Addendum #1

RE: REQUEST FOR TENDER #2024-137-P01947
Hess Street Elementary School – Renovation Project

Addendum No. 1

PROJECT:	HWDSB Hess Elementary School	DATE:	April 24 th , 2024
PROJECT #:	23035	FROM:	Binayak Raj Maurya
TO:	NGA Architects	ATTENTION:	Ivana Paukovic

2 PARTIAL GROUND FLOOR GIRLS & BOYS W/R NEW H.V.A.C. LAYOUT
SCALE: 1/4"=1'-0"

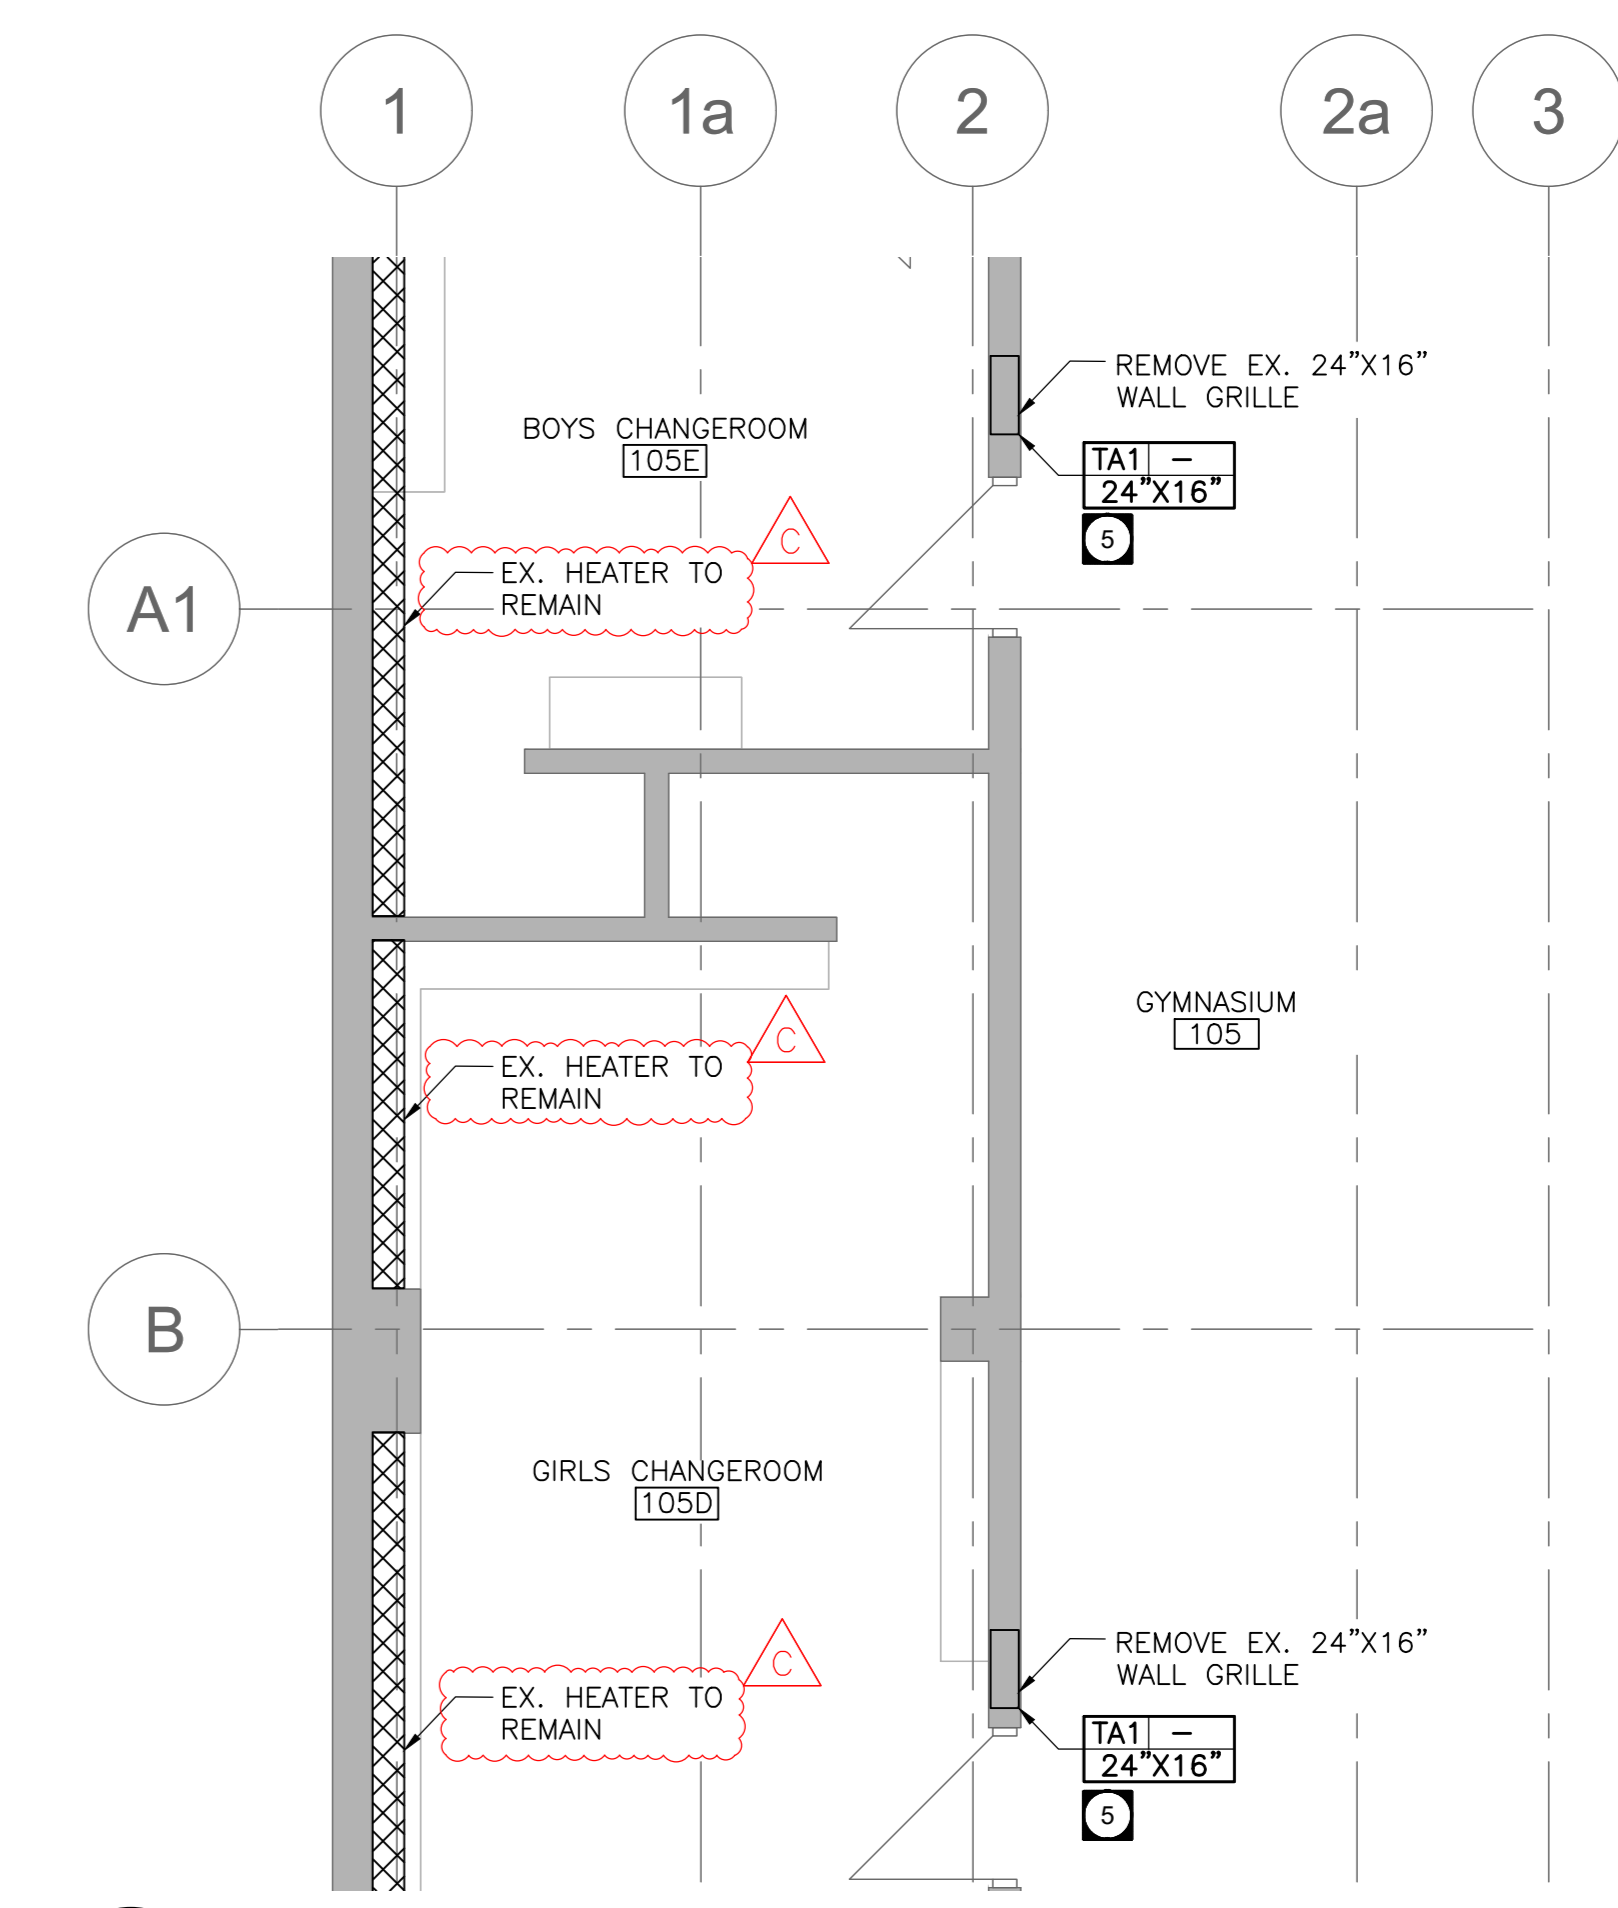
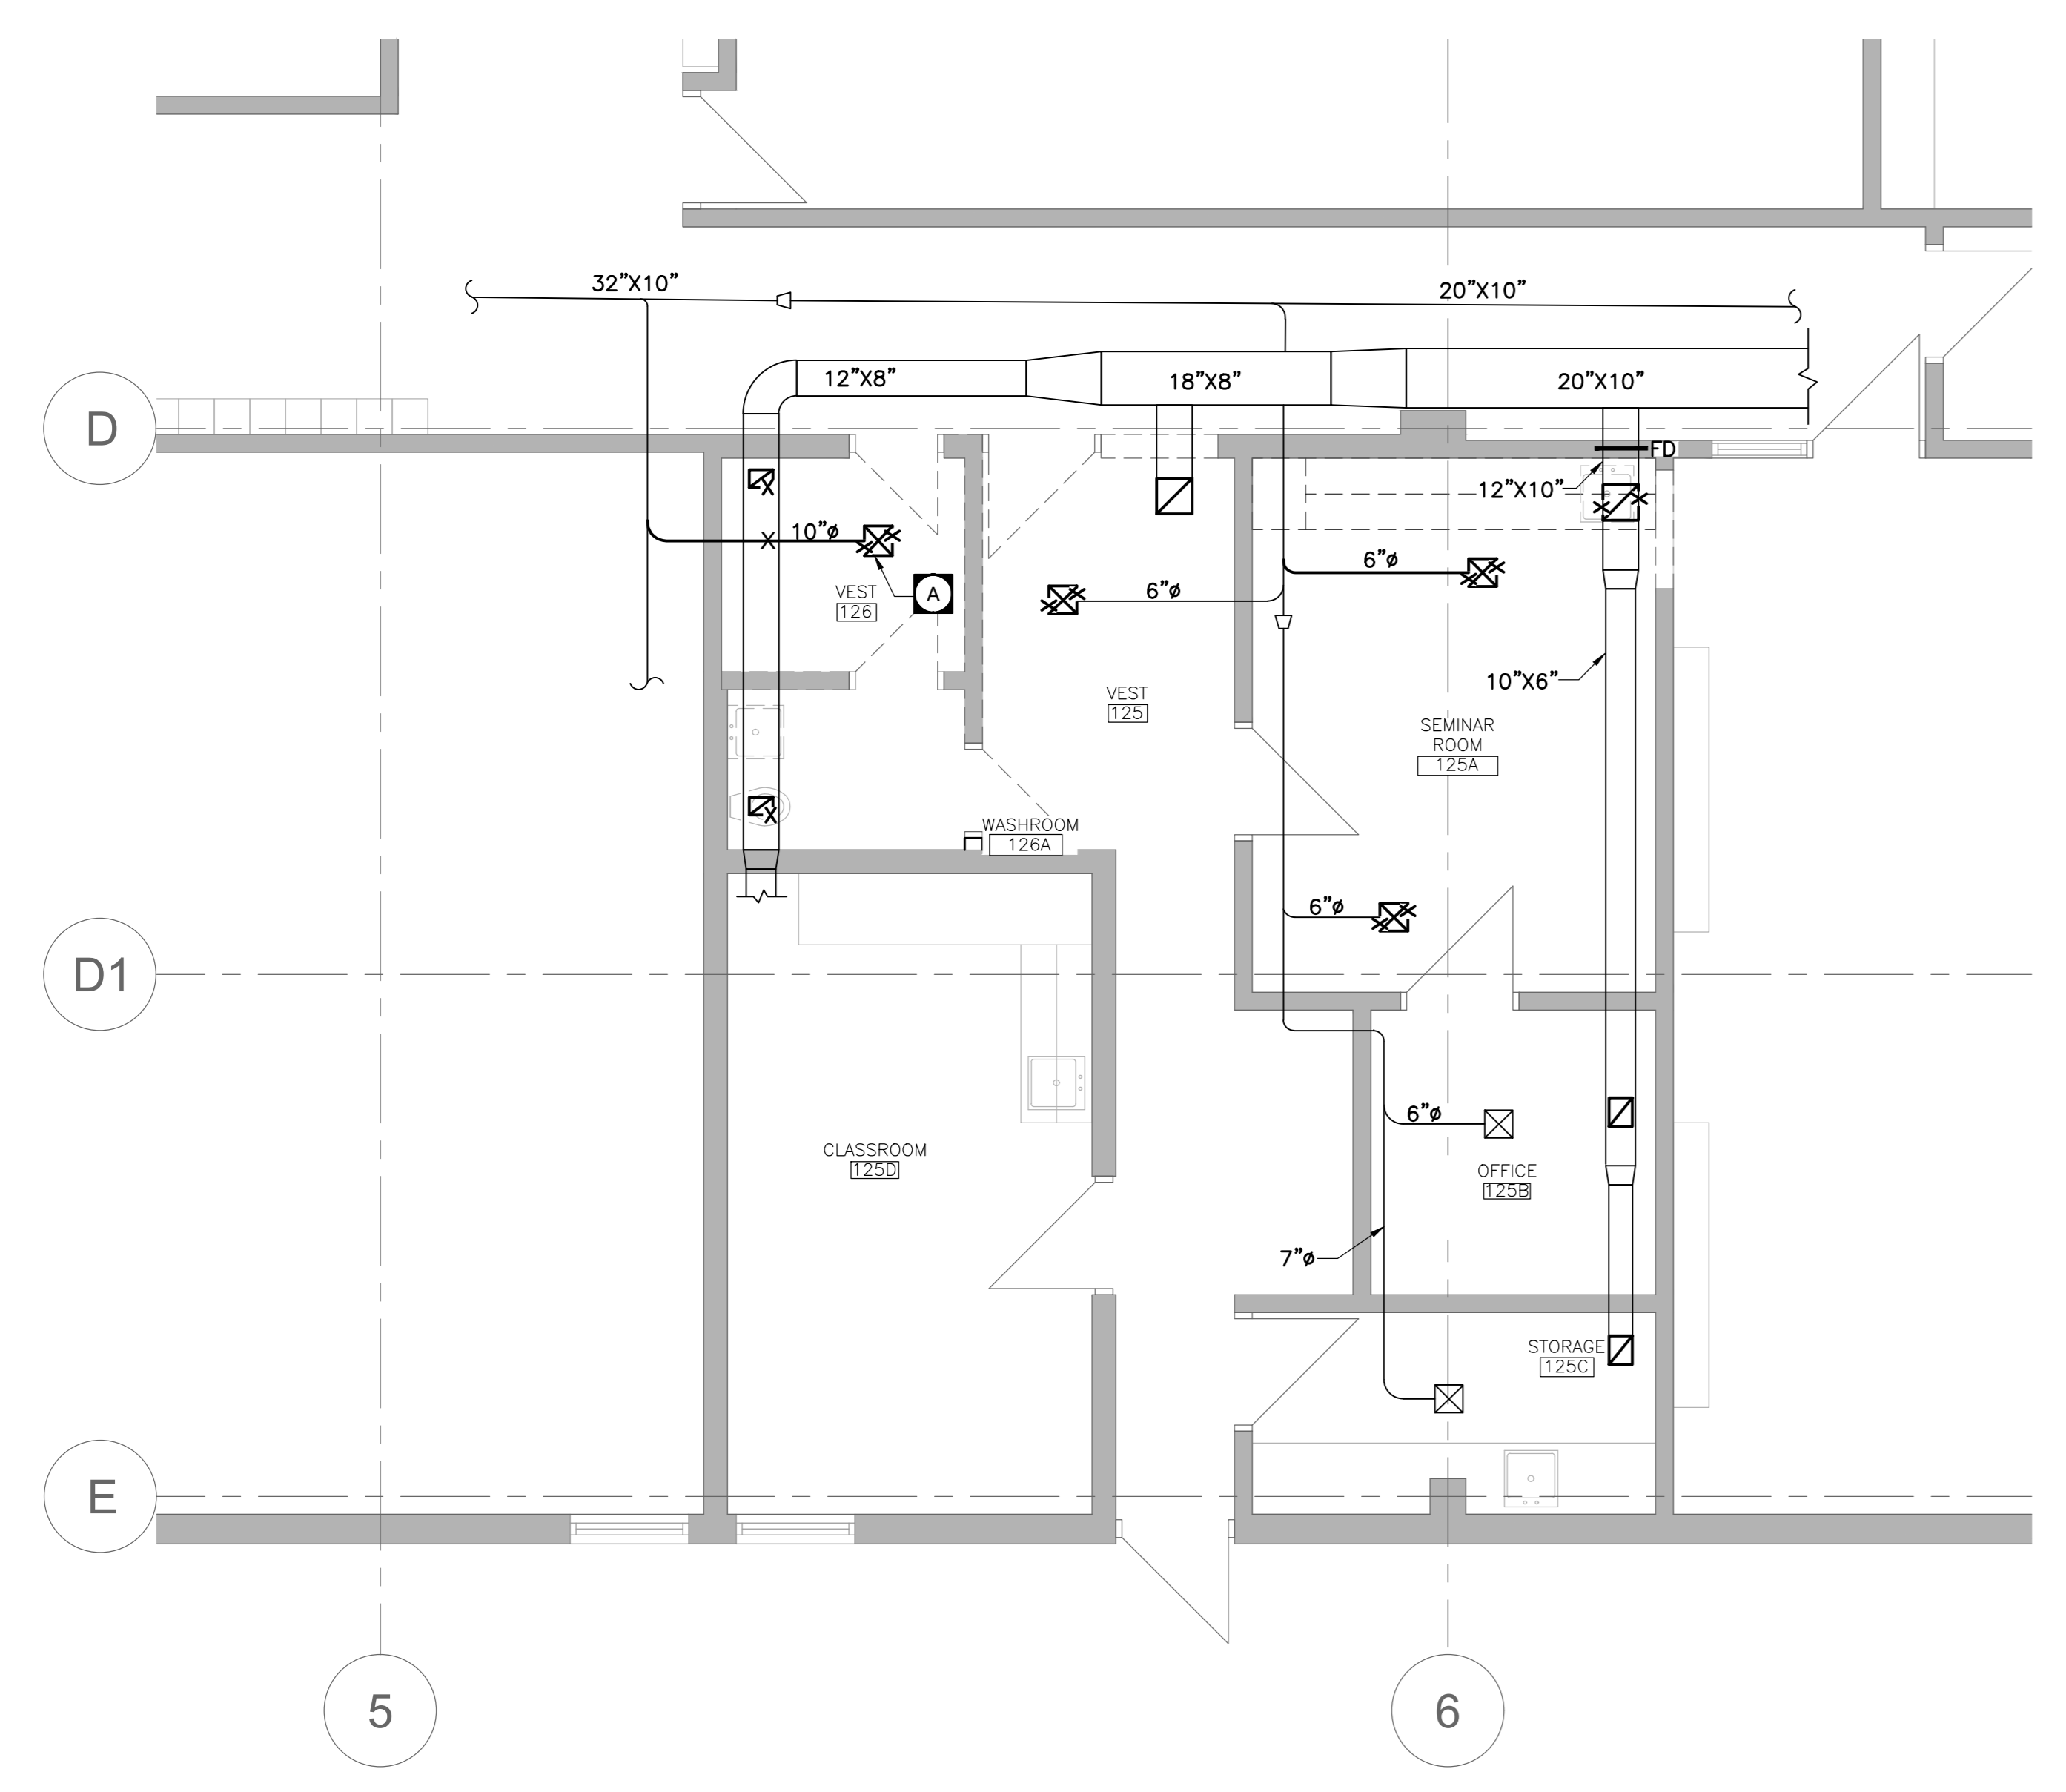
- 1) **Question:** On drawing M1.01, demo and new gym layout there is a reference to note 5. There isn't a note 5 under the new drawing notes.

- 4) **Question:** In various places on the drawings there are cross hatched symbols along the walls with no notes or references to what these are. What are these?

1.2 Refer to Mechanical Drawing M 1.01 Rev. C

- New note number-5 stated as “PROVIDE NEW TRANSER AIR GRILLES AS INDICATED” was added in the new drawing notes table.
- “EX. HEATER TO REMAIN” tag has been shown at the locations of existing wall fin heaters in Gymnasium-105.

Answer: Added note for new transfer grille. Refer to attached Addendum No. 1 by CK Engineering Inc dated April 24, 2024.

Answer: Existing heaters to remain. Refer to attached Addendum No. 1 by CK Engineering Inc dated April 24, 2024.
